**A6.4-INFO-MISC-004**

## Information note

**Summary of the comments received from stakeholders on the draft methodological tool “Emissions from electricity generation and/or consumption” from the call for public inputs to annexes of the MEP010**

Version 01.0

Figure 1: Illustration of the concept of CPP conceived as a system

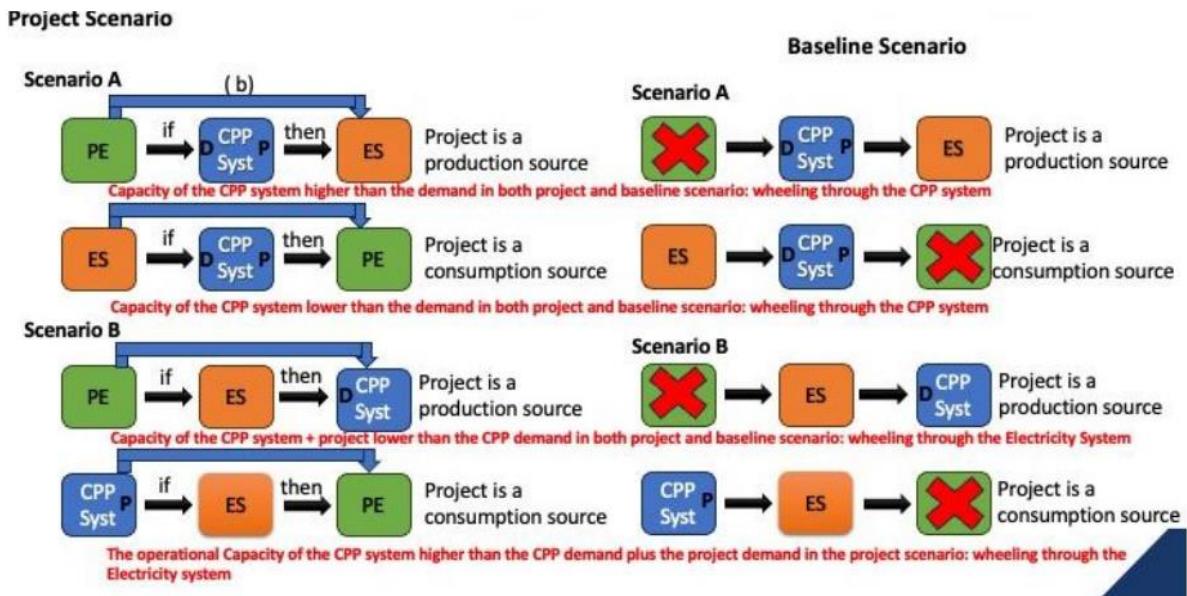
19. Within the Paragraph 22(b), sub-para (i) is correct if the project does not exchange electricity with the electricity system, but only with the CPP system. This example does not prevent the implementation of the project not to affect the electricity system. The CPP system can provide electricity the electricity from the CPP can be displaced by the electricity from the electricity system. The project/baseline is a production source. The electricity generation capacity of the CPP system plus the capacity of the project/baseline is lower than the CPP demand in both project and baseline scenario. Any amount of electricity sent by the project/baseline equipment to the Electricity System and not to the CPP system will lead to the same amount of electricity send by the Electricity System to the CPP system: this is wheeling through the Electricity System. The project is a consumption source. The operational capacity of the CPP system is higher than the CPP demand plus the project demand in the project scenario. It is attractive to run the CPP at its maximum capacity. Any amount of electricity consumed by the project from the Electricity System will lead to the CPP sending the same amount of electricity to the Electricity system: this is wheeling through the Electricity system. [4]
